14 Avenue N.W. Reconstruction and Mobility Improvements

Phase 2: What We Heard Report

Prepared by:
The City of Calgary Engage Resource Unit

Segment 1 - 24 Street to 20A Street N.W.

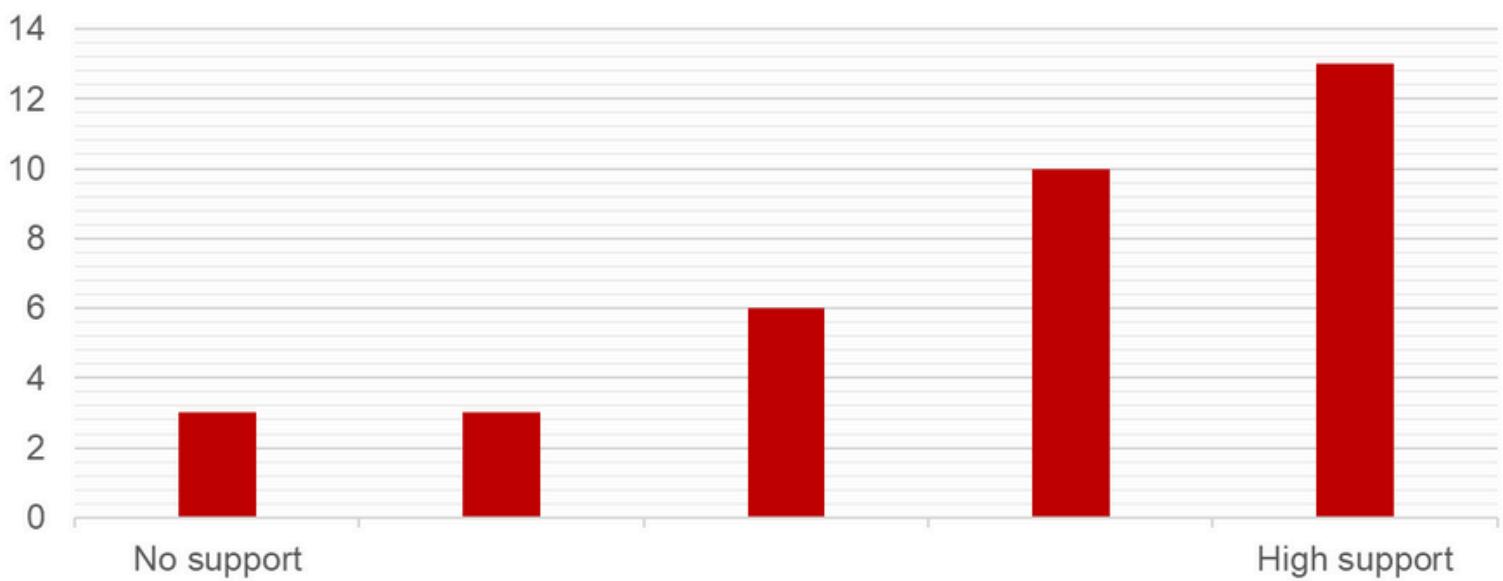
Theme	Sample Comments
Multi-Use Pathway	<p>[Rated 5] I really like the addition of a dedicated multi use pathway, especially since this street connects the neighborhood to so many pedestrian overpasses. I also like prioritizing pedestrian safety, especially around the elementary school so that kids feel safe walking from a young age.</p> <p>[Rated 3] My primary concern is that I have a driveway that accesses directly onto the North side of 14th Ave and wonder how the bike pathway will affect my property.</p> <p>[Rated 5] I like the multi use pathway, curb bumps and raised crosswalks. This will help reduce the number of speeding cars along the avenue and improve pedestrian safety.</p>

Theme	Sample Comments
Parking	<p>[Rated 3] Parking on the North seems to be more reasonable with more houses in the North face 14 Ave than houses on the south. Widen the sidewalks for walking and wheeling would increase the safety of community including drivers.</p> <p>[Rating 4] Looks good but in reality the parking on one side of street does not leave enough room for the two other lanes to actually pass each other, currently one has to pull into the oncoming lane if someone has parked one the road...people don't drive minis, they drive SUVS and trucks, let's be realistic please.</p> <p>[Rating 4] I will always be supportive of improvements to cycling and pedestrian infrastructure, though parking could be removed to further separate cyclists from pedestrians.</p>

Theme	Sample Comments
Curb extension bulbs	<p>[Rating 1] I agree with north side parking only along 14th Avenue. I do not agree with curb bulbs (expensive and not necessary). Install pedestrian crosswalk signage instead. We must educate our children how to properly cross a street.</p> <p>[Rating 2] I don't support a bulb at the intersection of 21A which would narrow the intersection. This would create more of a traffic issue and potentially more hazards for children crossing the road. We have lived on 21A for over 30 years and haven't noticed or heard of close calls affecting pedestrians and traffic incidents at the intersection. If the is an issue, may be other measures could be considered i.e. crosswalk signals. We notice more students using the alley between 21A and 21st to navigate their way through the area.</p> <p>[Rating 5] Curb bump outs and traffic calming are great additions around schools - would love to see continuous sidewalks for the pathway, especially where it crosses other connections. It's a great way to further calm traffic where it interacts with those outside of cars (walking or wheeling).</p>

Theme	Sample Comments
Accessibility	<p>[Rated 3] The multi use pathways should not have ramps on them for alley access. This is very hard to use for people walking, especially in the winter. Just have short abrupt ramps by the edge. It will force people to drive them at a slow pace and make is safer for everyone. You should have bulb outs for every intersection and raised crosswalks too. Why so few? This would be way safer for kids walking to school or to visit friends.</p> <p>[Rated 3] I'm not a huge fan of the combined bike/walk path. A lot of elderly people walk from our neighbourhood to the shops, and cyclists are not the best at letting people know when they are coming up behind you. I don't know why cyclists wouldn't just use the road in this location, as it isn't too busy. If cycling lanes are really that important, can they be separate from the sidewalk?</p> <p>[Rated 4] -like parking on one side BUT make parking limits at least 2 hrs (nothing meaningful like a class, professional service appointment, social/home care visit, etc) can be done in 1 hour and possibly limits change for evening and weekend hours.</p>

20A Street N.W. - Option 1

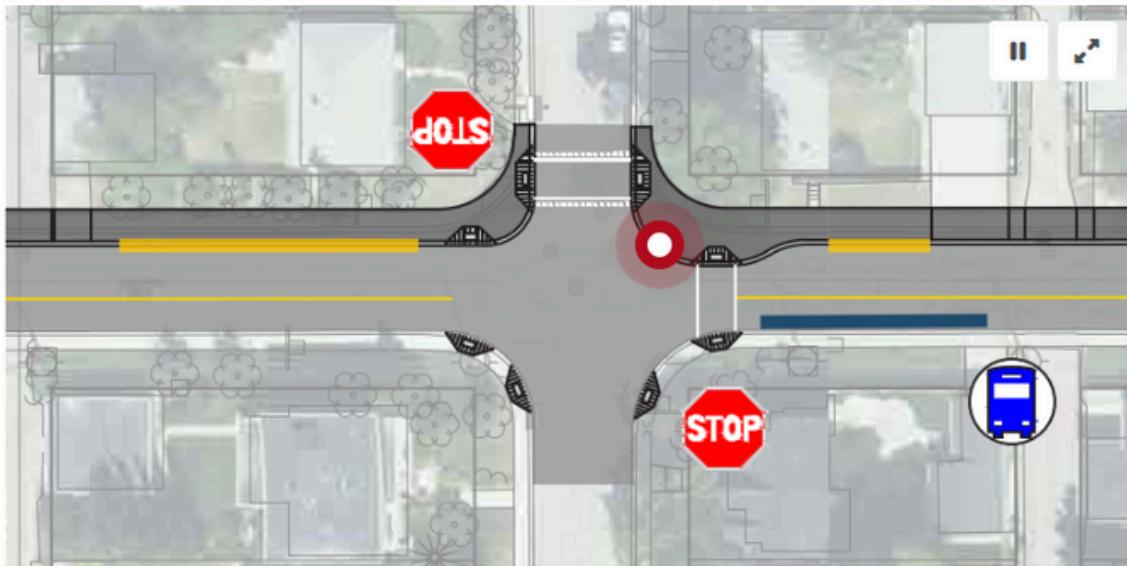
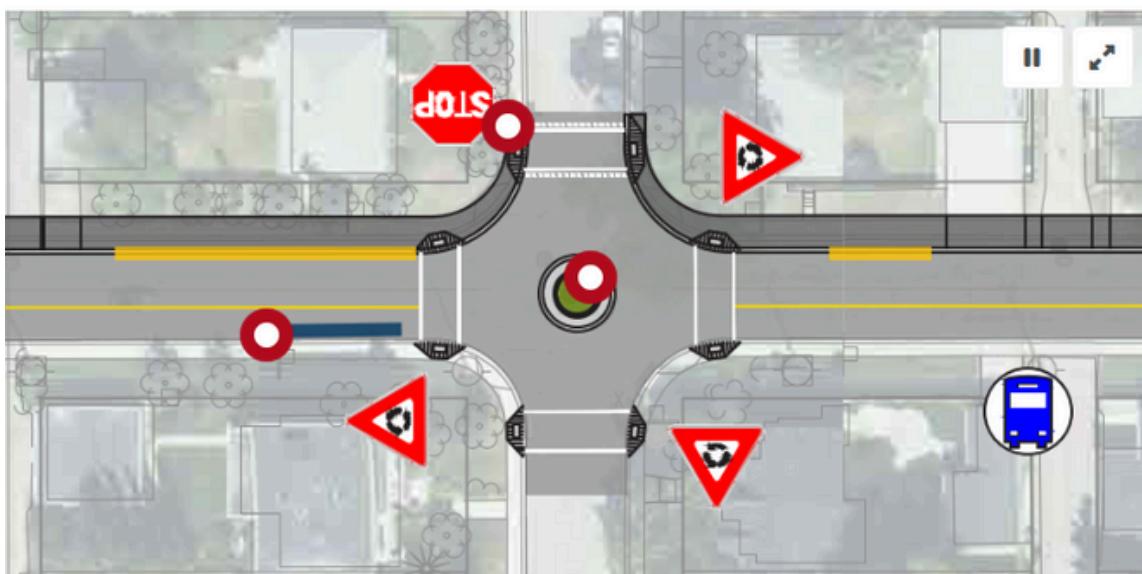
Theme	Sample Comments
Cost	<p>[Option 1 rated 5, Option 2 rated 2] Option 1 seems to be a resource effective solution that just need a little investment to enhance the current system that lead to the goals of improve safety for all (pedestrians, cyclists, drivers). Whereas option 2 increase the functionality that is just nice to have but not so much of necessity for safety; and would cost higher, which I would not support as much in this economic downturn we are experiencing.</p> <p>[Option 1 rated 5, Option 2 rated 4] Guess my logic would be to save a little here by going for option one and put the big money into the roundabout fix for the 19th Ave NW intersection.</p> <p>[Option 1 rated 4, Option 2 rated 5] While more expensive, as a person who bike commutes across the city fairly often I have found that traffic circles nicely slow down drivers in such a way that doesn't give preference, they seem to get used to watching out for each other and in so doing make it safer for both pedestrians and cyclists/scooter riders.</p>

Theme	Sample Comments
Roundabout, traffic circle, button	<p>[Option 1 rated 4, Option 2 rated 5] Traffic circles are great IMO. Would love to see some thought go into how the MUP will cross these intersections. Do they jog right, cross, jog left or is there a way to make it a continuous pathway and further calm traffic at the same time.</p> <p>[Option 1 rated 5, Option 2 rated 1] Stop signs will ensure vehicles come to a complete stop - this is important for children and pedestrians who use this route as a school crossing. Roundabouts do not stop vehicular traffic - only slow. Roundabouts also create safety issues for cars - aswhilst they are going around the circle, pedestrians can enter the crossing area behind them and may not be seen. A circle/roundabout would be better situation closer to the strip mall which has dreadful and dangerous access.</p> <p>[Option 1 rated 5, Option 2 rated 1] don't like traffic buttons - can squeeze out bikes.</p>

Segment 2 - 20 Street N.W. to North Hill Centre pedestrian overpass

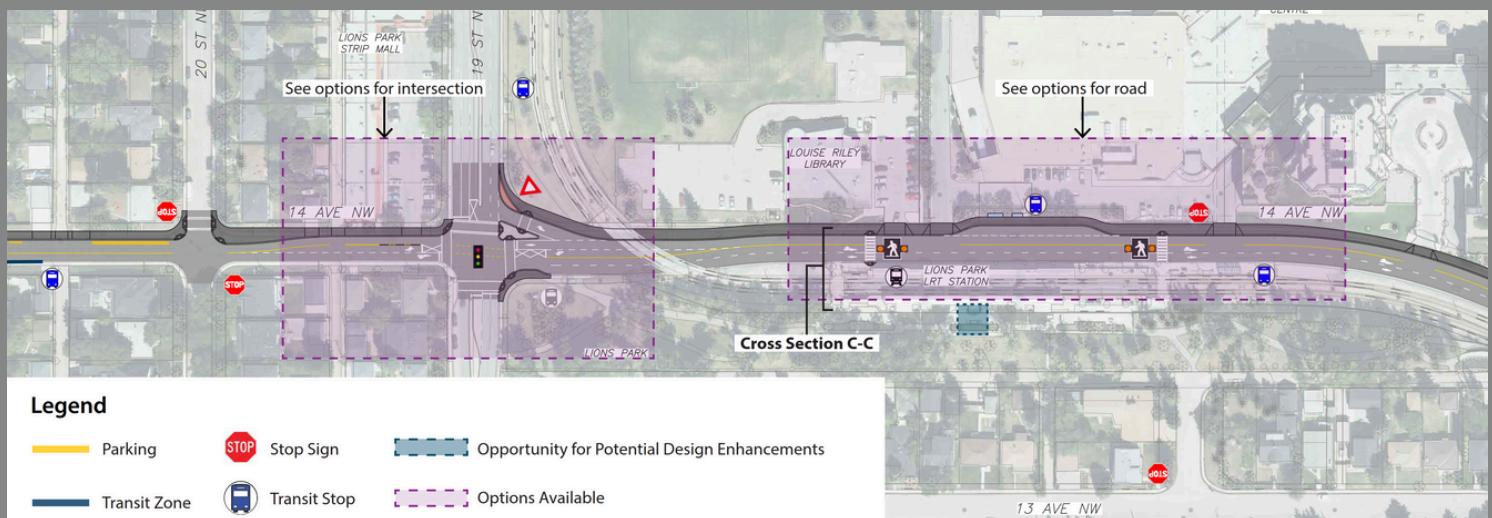
Theme	Sample Comments
Pathways and sidewalks	<p>[Rated 4] I fully support wider multi-use pathways and less road traffic lanes. Riding with children on sidewalk en route between SAIT and Louise Riley regularly, the narrow pathway has led to several close calls of my daughter falling off the narrow curb into the traffic lane.</p> <p>[Rated 3] The multi use pathway should NOT have ramps built in them for cars, makes it challenging to walk on especially in winter.</p> <p>[Rated 3] I think that putting the pathway on the north side ignores the fact that most foot traffic in this area is either travelling to or from the lrt station.</p> <p>[Rated 5] Wider sidewalks are much better especially if they are multi-use, i.e. bikes take part of the path.</p>

Theme	Sample Comments
Crossings to Library/ Safeway	<p>[Rated 2] This is the area that has the most safety concerns. In my short time in the neighbourhood, I've had cars almost hit me several times crossing 19 St NW coming from the Safeway, and crossing from the LRT by the library. The most common issue is southbound drivers not slowing down or stopping when they are turning right onto 14 Av NW. The proposals for crossing from the LRT station are inadequate to address the issues with cars turning out of the Safeway or reducing jaywalking by putting crosswalks where people actually want to go.</p> <p>[Rated 4] Will be nice to have some more space in front of Louise Riley to appreciate the lovely area directly in front of it, which would benefit from benches to admire the green space. Could something be done to access the library parking lot from elsewhere other than directly next to it when attempting to enter from north hill mall?</p> <p>[Rated 4] My kids and I bike to the library from the SAIT direction and the crazy unsafe turns that people are constantly making across the path of bikers and pedestrians is very frustrating and sometimes scary.</p>

Theme	Sample Comments
Pathways and connectivity	<p>[Rated 3] strong support for improved cycle connectivity E-W along 14th Avenue. Could be better improved by better connectivity to the south side of 14th Avenue and Lion's Park.</p> <p>[Rated 3] Thirdly, please connect the pathway to existing bike/running paths, between 24st-10st. Thirdly, please connect the pathway to existing bike/running paths, between 24st-10st.</p> <p>[Rated 4] There needs to be clear connections to pathways, so people aren't just spit out into traffic.</p> <p>[Rated 4] CONNECT THE NEW PATHWAY TO THE PATHWAY ON 16 AV NW - WHY ARE WE BUIDLING MISSING LINKS INTO OUR NETWORK ??!!!</p> <p>[Rated 5] A multi use path along the north side would be great. I would only like to see a better bike connection at Lions Park as many cyclists use 17A street from West Hillhurst and connection to the MUP would be important - otherwise cyclists will continue to ride on the south side and cross at the lights (not always correctly) or ride up 19 Street which can be dangerous for everyone. SO improved connection to the MUP would be a suggestion.</p>

19 Street N.W. - Option 1

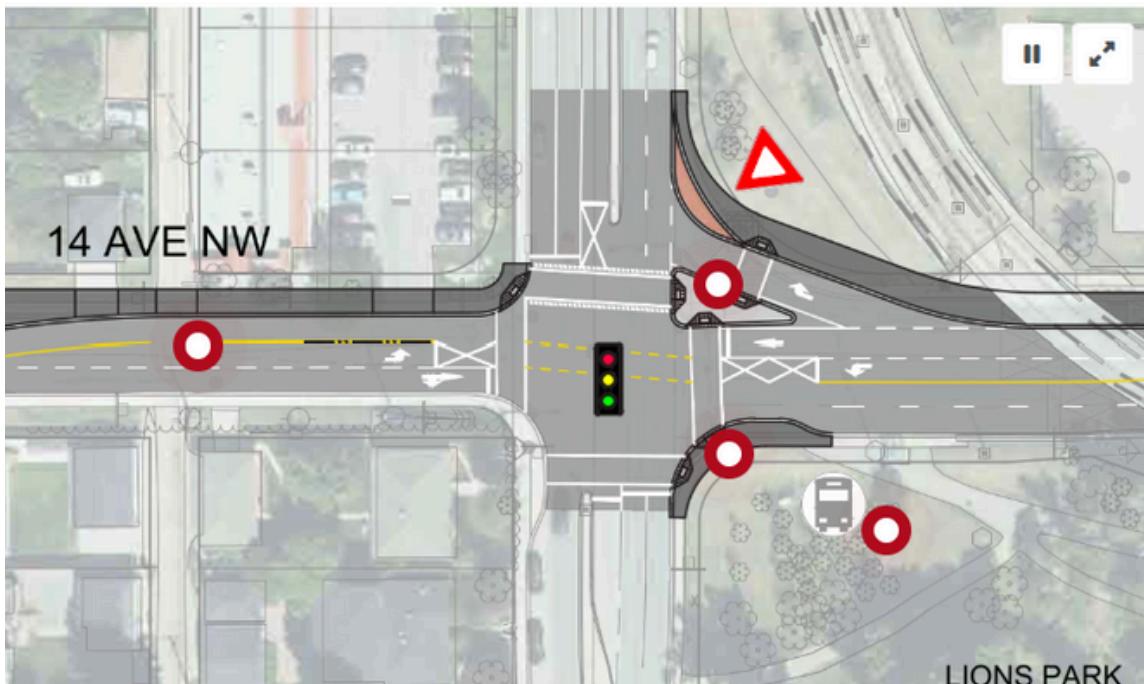
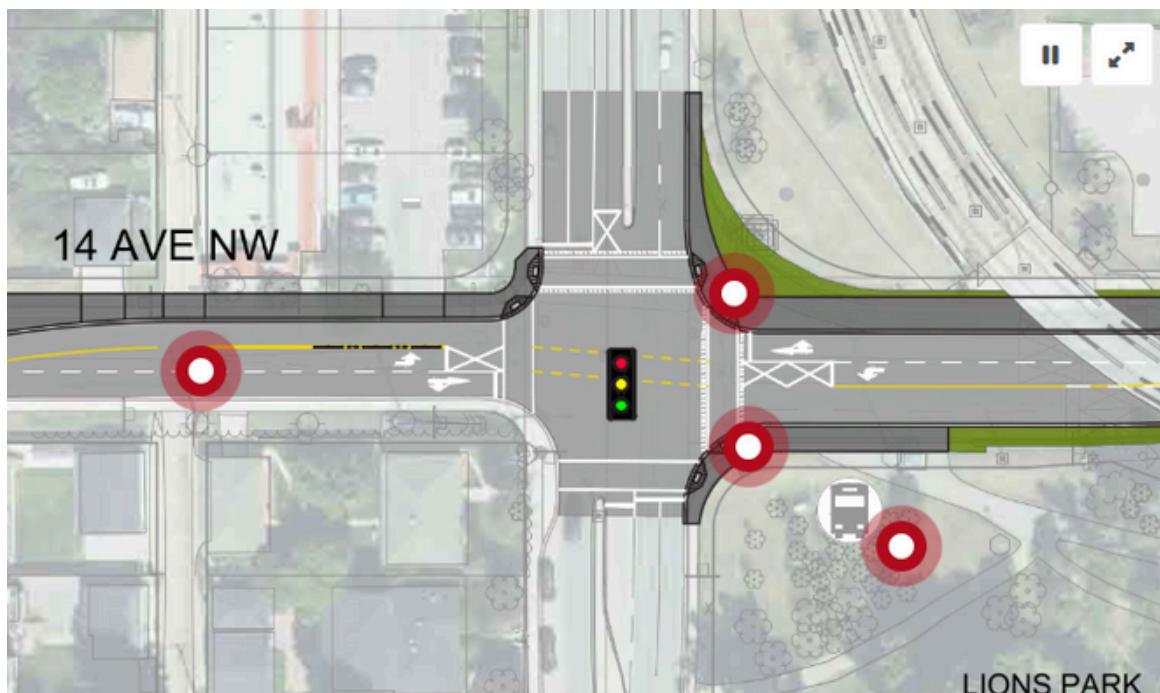
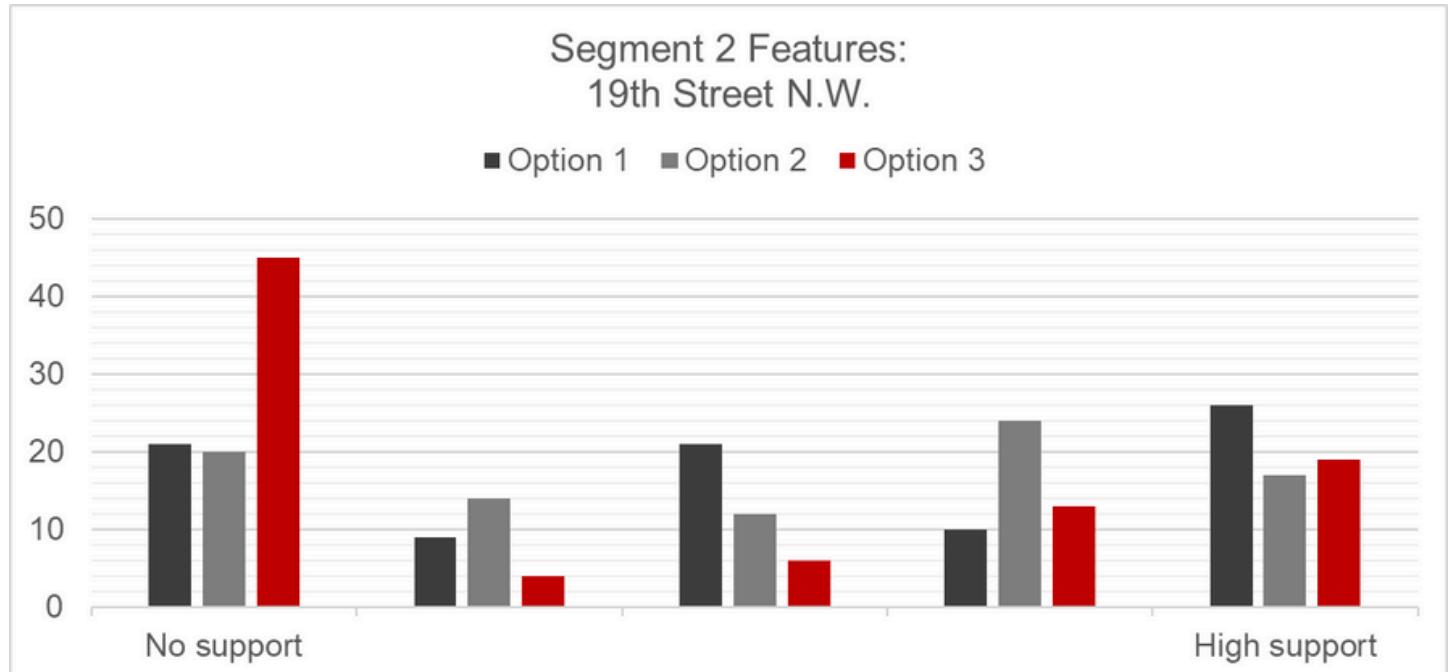
Theme	Sample Comments
Roundabout - In Favour	<p>[Option 1 rated 2, Option 2 rated 5, Option 3 rated 3] circle make sense but during rush house, I would foresee ppl travelling north bound turning westbound on 16 would easily clog it giving traffic circle turns northbound into single lane. If 16th and 19th turn traffic circle then yes. All for traffic circle as long as blocks use it.</p> <p>[Option 1 rated 1, Option 2 rated 1, Option 3 ranked 5] I want the roundabout so I don't have to stop when going down 19 St.</p> <p>[Option 1 rated 3, Option 2 rated 4, Option 3 ranked 5] The roundabout eliminating the traffic signal issues from the LRT would be a huge advantage, as well as eliminating pedestrians having to wait for the traffic signal to cross. It would be worth the additional funding</p>

Theme	Sample Comments
Roundabout - Against	<p>[Option 1 rated 1, Option 2 rated 1, Option 3 rated 1] do not think a traffic circle will improve anything for walking, driving or biking. I use the intersection for all three. It is not a good corner for a traffic circle especially during the rush hour. It would especially be a bad idea for drivers making left turns. Horrible idea.</p> <p>[Option 1 rated 5, Option 2 rated 2, Option 3 rated 1] The roundabout design is not an ideal design for this area. Due to high levels of pedestrian traffic coming from Lions Park, especially during rush hour, you can expect cars to be backed up, possibly to trans Canada. Furthermore, the fact that there is a train track right beside the roundabout will lead to a total freeze in vehicle traffic within the roundabout when a train is passing by. A signalled intersection for this area is ideal.</p> <p>[Option 1 rated 5, Option 2 rated 3, Option 3 rated 1] That traffic circle configuration is way too confusing, especially considering it is so close to the Trans Canada Hi-Way and many businesses and services that bring people to the community infrequently. The traffic mostly backs up here because of a backlog of vehicles turning left from Northbound 19th street onto Westbound 16 Ave. If that turn signal time could be lengthened, it would help a lot. As a resident who frequently heads straight through on 14 Ave westbound, I prefer to maintain a separate right turn lane to keep the traffic moving.</p>

Theme	Sample Comments
Slip Lane	<p>[Option 1 rated 2, Option 2 rated 4, Option 3 rated 5] Option 1 - While it's an improvement over the previous design, this still looks like it would be scary to cross as a pedestrian. The slip lane is what does it for me, as well as the number of lanes. I don't think 14 Ave needs all that many lanes.</p> <p>[Option 1 rated 1, Option 2 rated 4, Option 3 rated 5] A slip lane is a regressive proposal that is NOT ALIGNED from your own guiding documents. This is contradictory to Calgary's Complete Streets and Vision Zero design principles. Option 1's slip lane would cater to driver speed and convenience at the expense of pedestrian and cyclist safety.</p> <p>[Option 1 rated 1, Option 2 rated 5, Option 3 rated 3] Making people walking and wheeling cross a slip lane (in Option 1) is bad - pedestrians should be the priority at this intersection, not drivers.</p>

Segment 2: Lions Park Station Area - Options

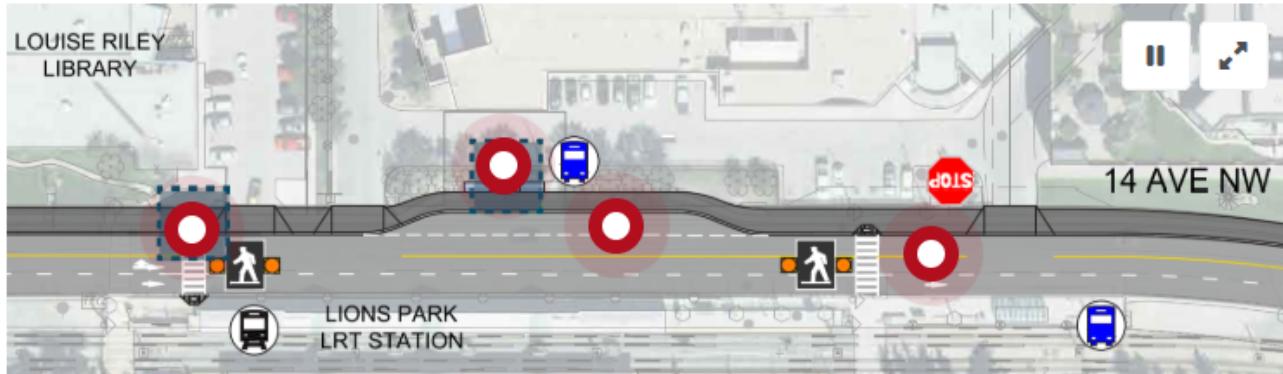
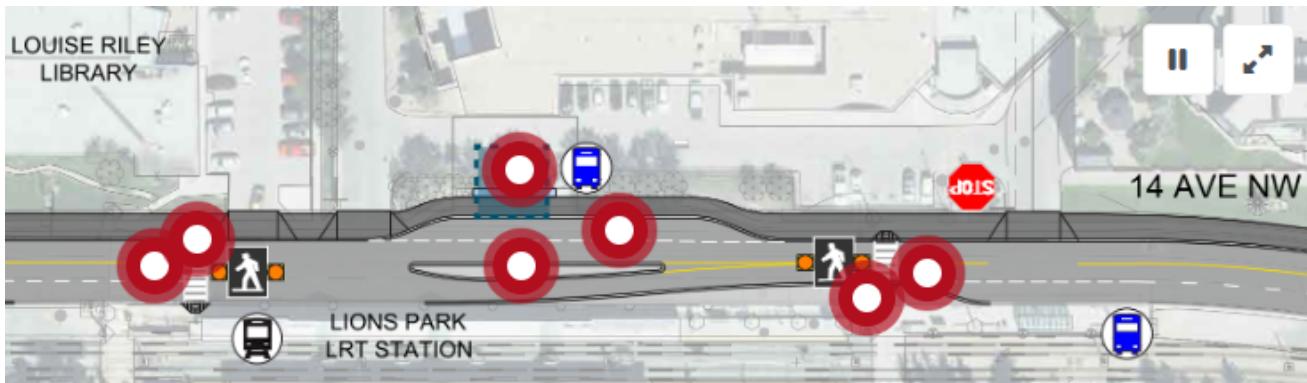
Theme	Sample Comments
Jaywalking	<p>[Option 1 rated 4, Option 2 rated 1] Jaywalking is a car centric mentality that detracts from good street design. Find out why people are jaywalking and design the street so they can do the same thing but safely.</p> <p>[Option 1 rated 3, Option 2 rated 3] It is my understanding higher "fencing" will be installed to stop train users from jaywalking between the two current crosswalks. Unless the fencing is at least 5 feet high, there will be those that jump it. Not sure what the best solution to this would be but people will always find the shortest distance between 2 points.</p> <p>[Option 1 rated 1, Option 3 rated 3] This is a transit and pedestrian street. We need to quit acting like it's 1929, and show the most frequent users of this space some respect. Why not "deter jaydriving" with a woonerf raised crosswalk design?</p>

Theme	Sample Comments
Wider pathway	<p>[Option 1 rated 1, Option 2 rated 1] Would be great if for Option 1 or 2, the extended pedestrian pathway could include cyclists / active transport wheelers as well.</p> <p>[Option 1 rated 2, Option 2 rated 4] This widened pathway needs to extend further east beyond the bus parking bay to N Hill Mall's SW entrance. The current well-trodden soil substantiates this imperative.</p> <p>[Option 1 rated 2, Option 2 rated 4] Add a crossing if possible (or make the west crossing a wider scramble crossing) to improve the desire path to the sidewalk to Safeway and the MAX Orange BRT.</p>

Theme	Sample Comments
Median	<p>[Option 1 rated 4, Option 2 rated 1] An elevated median and curb bulb will just slow traffic down. There is already congestion in this section so we need more flow of vehicles.</p> <p>[Option 1 rated 5, Option 2 rated 1] The raised median island in option 2 will only provide a "safe haven" for jay-walkers.</p> <p>[Option 1 rated 3, Option 2 rated 1] A raised median island doesn't seem to discourage jaywalking instead having a platform to be safe while jaywalking would encourage more jaywalkers.</p> <p>[Option 1 rated 5, Option 2 rated 5] Option 2 - The added islands and bump-outs are nice, not only to control traffic, but also to calm it and provide refuges for pedestrians crossing. That includes the middle island there, as I can imagine pedestrians will inevitably cross</p>
